April 24, 2024

PROJECT NAME: PIONEER RANCH (AKA: JB RANCH (ARMSTRONG))

PROJECT NUMBER: 2021070045

APPLICATION: PUD MASTER PLAN #27879

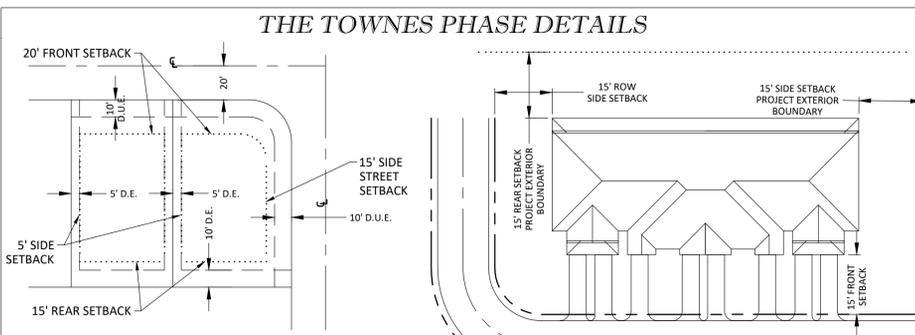
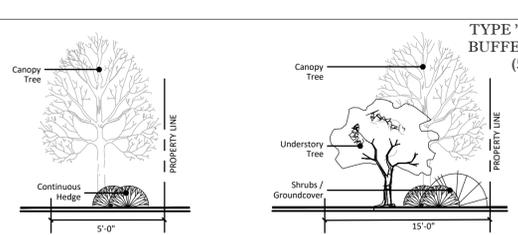
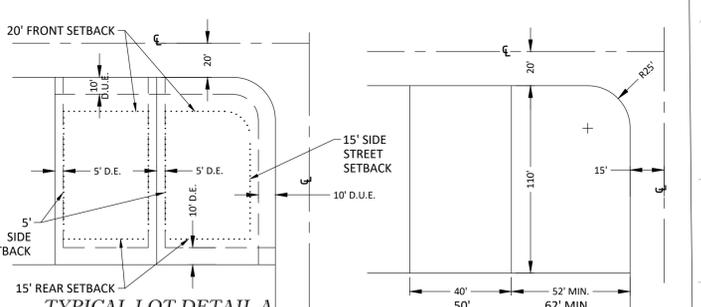
REMARKS: The master plan includes a lot typical detail that labels typical drainage easements. Approval of the master plan with this typical detail does not constitute approval of these easement widths in all locations for the development. Individual easement widths will be evaluated in conjunction with the proposed infrastructure at improvement/site plan and/or final plat submittals.
